*Ross ISR Project USNRC License Application
Crook County, Wyoming*

**RAI Question and Answer Responses
Environmental Report
Docket #40-09091**

Prepared by:
Strata Energy Inc.
1900 W. Warlow Drive, Bldg A
PO Box 2318
Gillette, WY 82717-2318

MARCH 2012

ER RAI RESPONSE	
FIGURE ER RAI CI-2-1	
EXISTING AND POTENTIAL MINERAL DEVELOPMENT PROJECTS WITHIN 80 KM OF THE ROSS PROJECT AREA	
Drawn By: MBM	
Checked By: JWF	
Date: 3/27/12

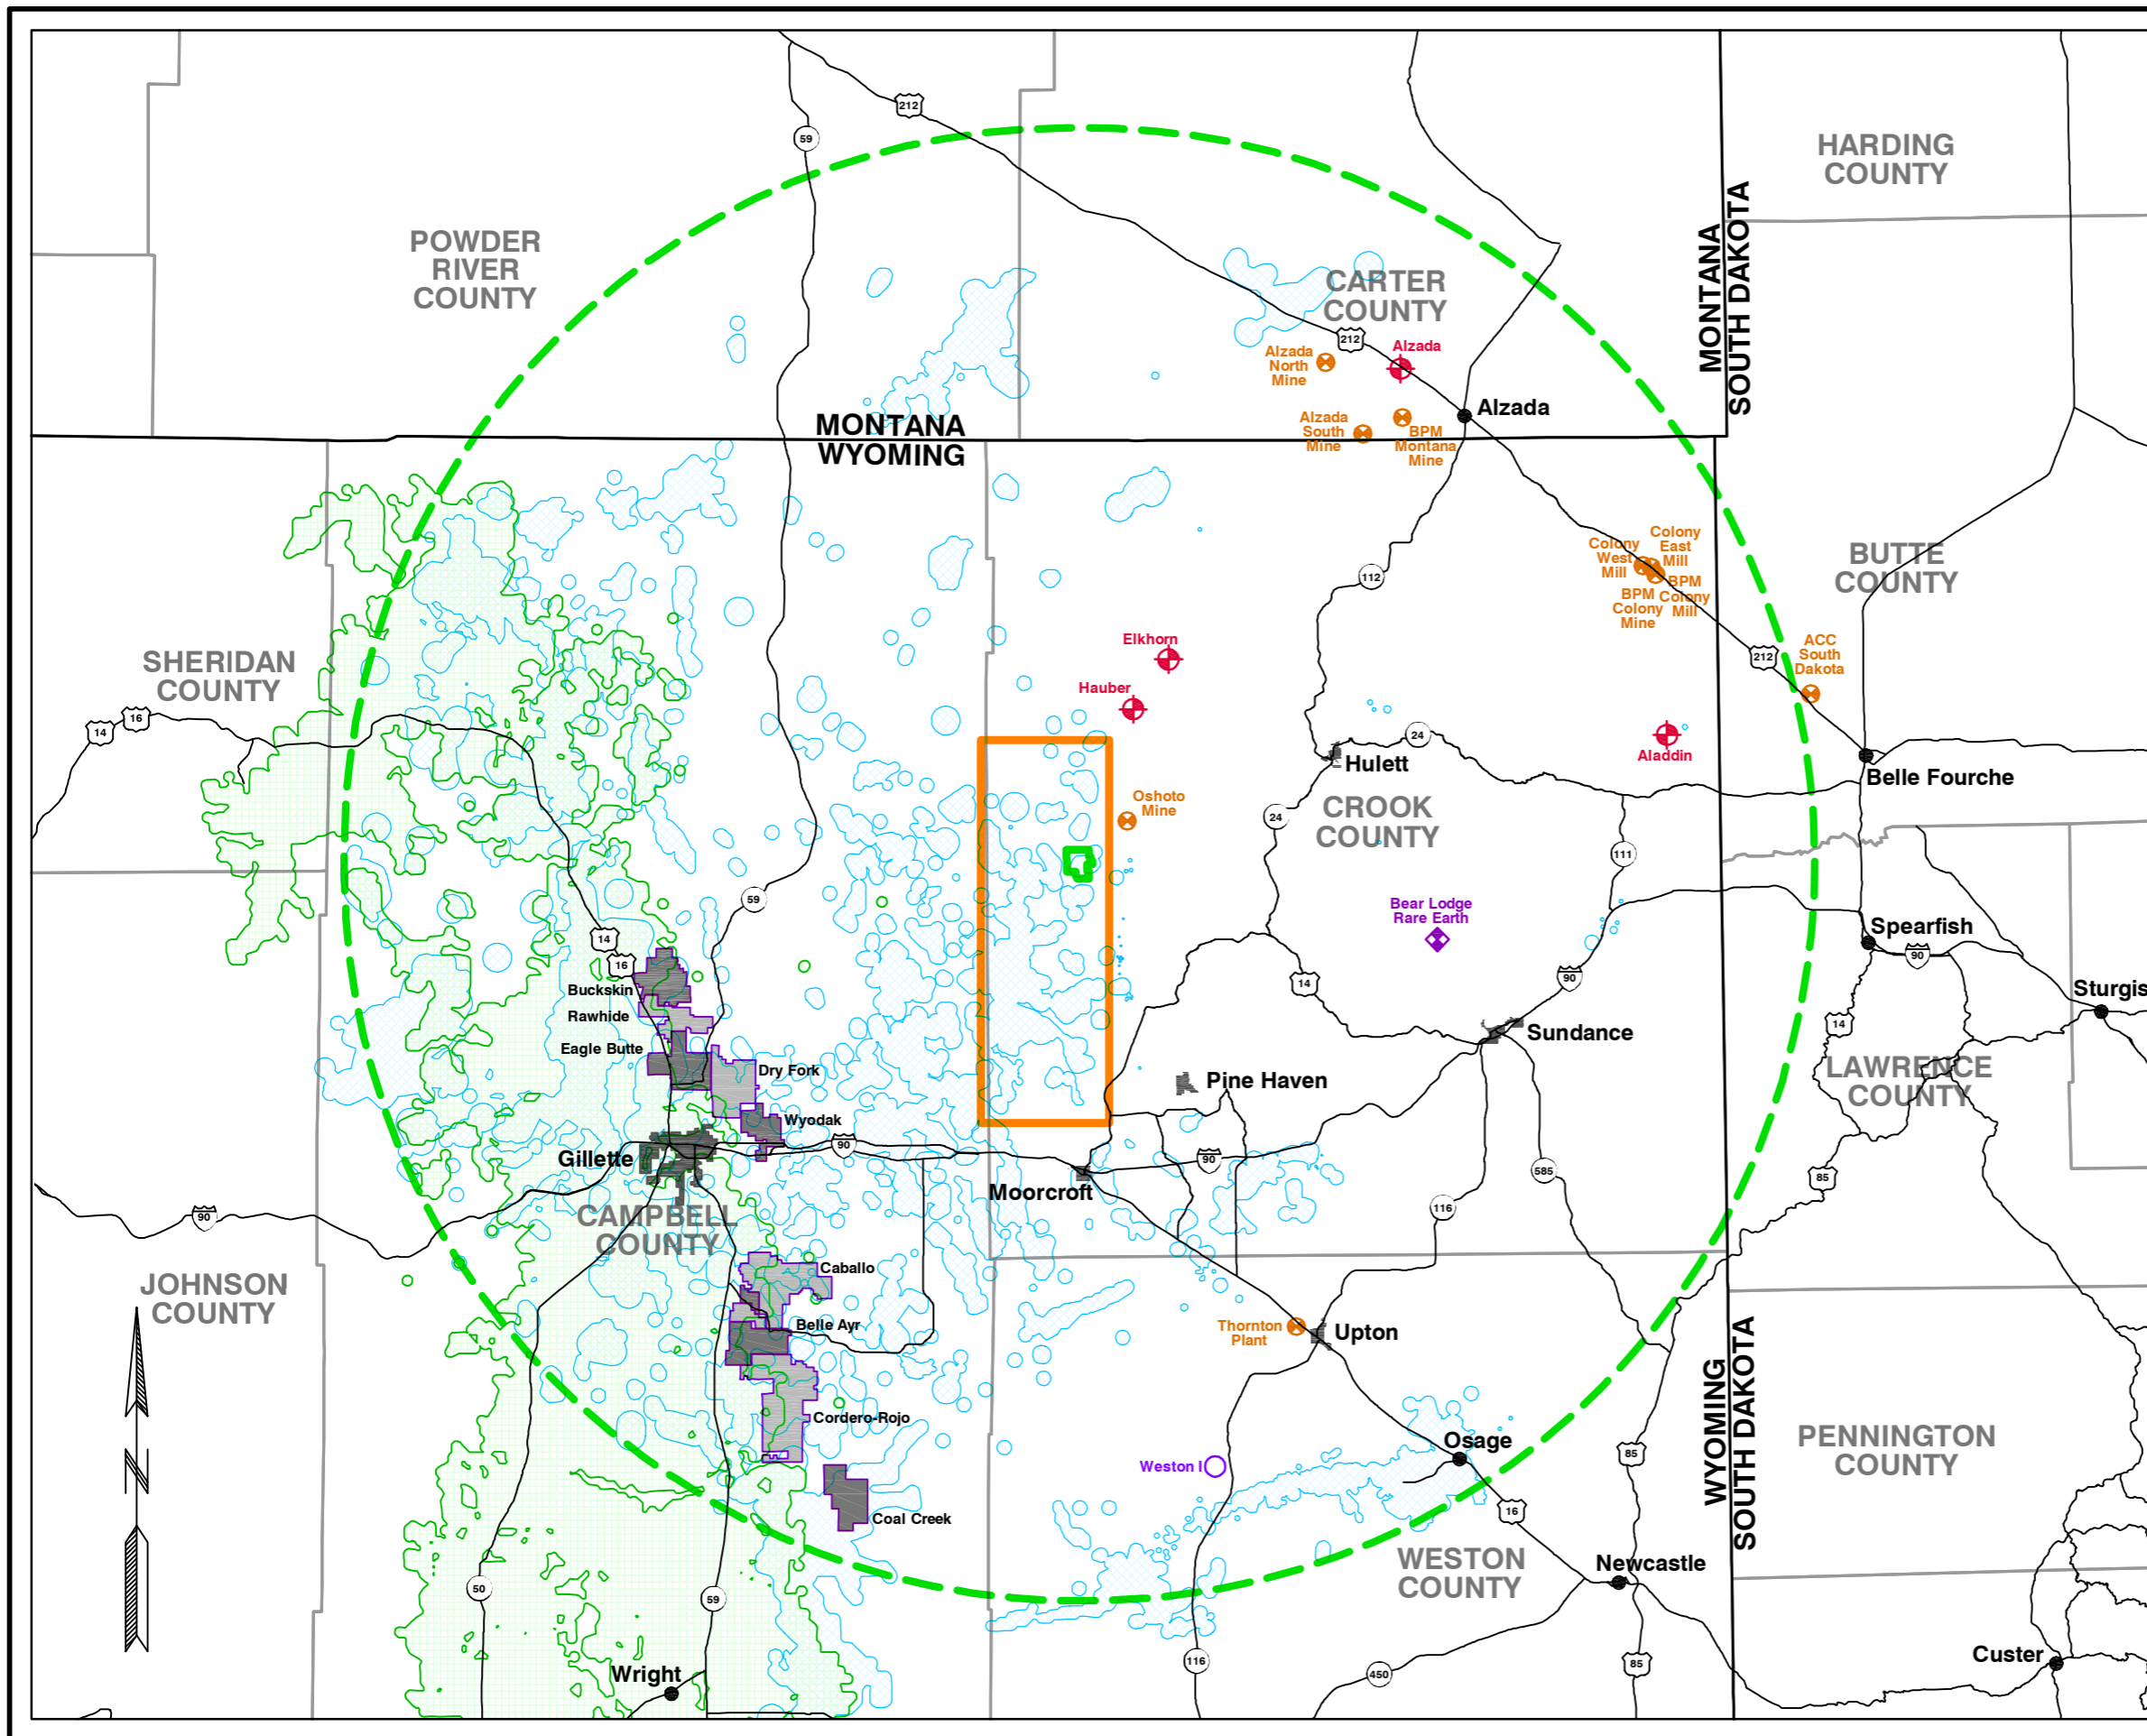
In order to assess the cumulative impacts of local, adjacent, and/or nearby operations, those operations must first be identified (in more detail than what is presented in Section 2.2.7 of the ER). For example, if another facility whose purpose is to retrieve other underlying mineral resources is to be constructed and operated in or near the Lance District, then Strata's Proposed Action could compete with the nearby operation for local workers, a socioeconomic cumulative impact. In addition, if there are other facilities near the Ross Project site, the total increase in traffic that would be associated with the construction and operation of the nearby facilities could cause cumulative impacts to transportation. Thus, it is important to identify and describe any current and anticipated projects that may cumulatively impact resources anticipated to be impacted by the proposed Ross Project. The assessment of cumulative impacts is conducted under the authority of 10 CFR Part 51.

Figure ER RAI CI-2-1 depicts the current and potential projects included in the cumulative impact analysis.

Figure ER RAI CI-2-1 shows the location of active coal mines in relation to the Ross ISR Project. Within a 50-mile radius of the Ross ISR Project there are nine active coal mines. The owners and locations of these mines in relation to the Ross ISR Project are provided in Table ER RAI CI-2-1.

Figure ER RAI CI-2-1 depicts existing oil and gas fields and coal bed natural gas (CBNG) fields within 50 miles of the proposed Ross project area (DOE 2012a, 2012b). As described in ER Section 2.2.7.2.3, there are three producing oil wells, two water injection wells, and three water supply wells used for enhanced oil recovery within the proposed Ross project area. Mitigation measures for potential impacts to the enhanced oil recovery water supply wells are described in ER Section 5.4.2.1.2 (pg. 5-36) and include working with the oil production company to temporarily provide an alternate water supply or alternate means of enhanced oil recovery. See also the response to TR RAI 18 in the TR RAI response package, which describes how Strata is currently working with Merit to discontinue use of their water supply wells within the proposed Ross project area prior to ISR operations. The density of oil and gas development is typical of the region as shown on Figure ER RAI CI-2-1. No CBNG well fields are within the proposed Ross project area due to its location stratigraphically below the Wasatch and Fort Union formations where the CBNG production occurs (refer to ER Section 2.2.7.3).
